Draft Decision

Dampier to Bunbury Natural Gas Pipeline

Application for Agreement Under Section 8.21 of the Code – Stage 5 Expansion

Submitted by DBNGP (WA) Transmission Pty Limited 27 April 2006

Figure 1 DBNGP Fuel Gas & Throughput

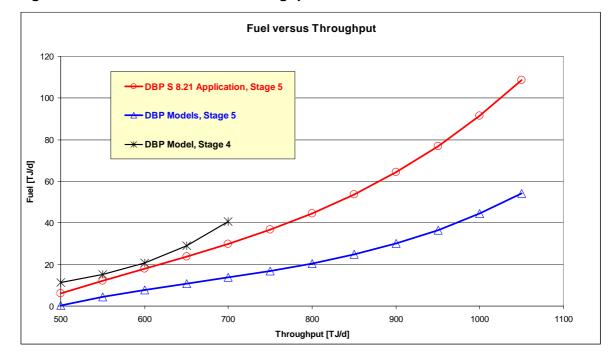
74. The Authority modelled the above fuel gas usage equation. As a result of this analysis, the Authority identified a very high fuel gas usage which approached 10 per cent of total gas throughput. DBP initially confirmed the equation was correct (letter of 28 February 2006). However, when the models requested by the Authority, as mentioned in paragraphs 70 and 71 of this decision, were subsequently provided (13 March 2006), the Authority noted that the equation set out in paragraph 8.8 of DBP's supporting submission contained apparent errors. Figure 1 below illustrates the Authority's analysis of the relationship between fuel costs and throughput. The curve labelled "DBP Models, Stage 5" in Figure 1 below is the Authority's recalculation of fuel gas requirements (TJ per day) based on the revised information provided by DBP, which is significantly less than that originally submitted by DBP as illustrated in the curve labelled DBP's s8.21 Application Stage 5.

75. DBP's most recent advice is that the fuel gas usage information provided in its initial models, provided on 13 March 2006, is correct. However, DBP claimed the modelled fuel gas curve is commercially confidential and did not agree to the Authority publishing a correction to its published fuel gas curve. The above graph does, however, illustrate the magnitude of the apparent error. The Authority's

Figure 2 Sub-section 8.16(a)(ii)(A) Anticipated Incremental Revenue Test Over an 80 Year Period for New Facilities Investment of \$1,521 Million

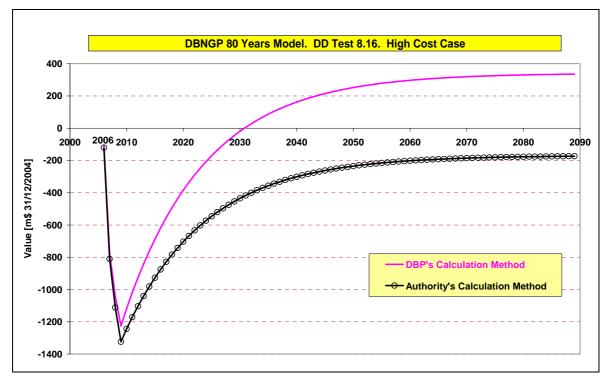
95. The result of the Authority's calculations is represented in the graph below. Details of the Authority's calculation are contained in <u>Appendix 1</u>.

- 96. The Code is silent on the period over which the 8.16(a)(ii)(A) test is to be applied. Figure 2 shows that, based on the Authority's calculations, DBP's proposed Stage 5 expansion investment fails the Anticipated Incremental Revenue test under subsection 8.16(a)(ii)(A) of the Code.
- 97. APIA has commented in its submission that it believes that the test under subsection 8.16(a)(ii)(A) of the Code should be applied over the economic life of the asset rather than over some shorter period. Under the current Access Arrangement the economic life of the pipeline expansions approved as New Facilities Investment has been set to 70 years for looping and 30 years for compression. The Authority's calculations for the above test used the current Access Arrangement assets economic lives and performed its analysis over a period of 80 years.

Figure 3 Cost of Service Annual Reference Tariff at a Load Factor of 1

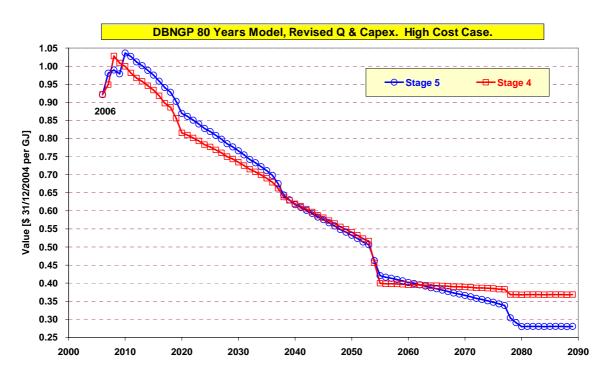
- 105. It should be noted from Figure 3, that the low tariffs in 2007 and 2009 reflect a difference in the timing of New Facilities Investment and forecast load. From 2010 total New Facilities Investment is taken into account when calculating depreciation and return on assets.

- 106. Figure 3 shows that the cost of service Reference Tariffs for the Stage 5 expansion exceed the Reference Tariffs that would apply following completion of the Stage 4 expansion. This figure shows that the Stage 5 Reference Tariffs would exceed the Stage 4 Reference Tariffs from 2009 until 2039.
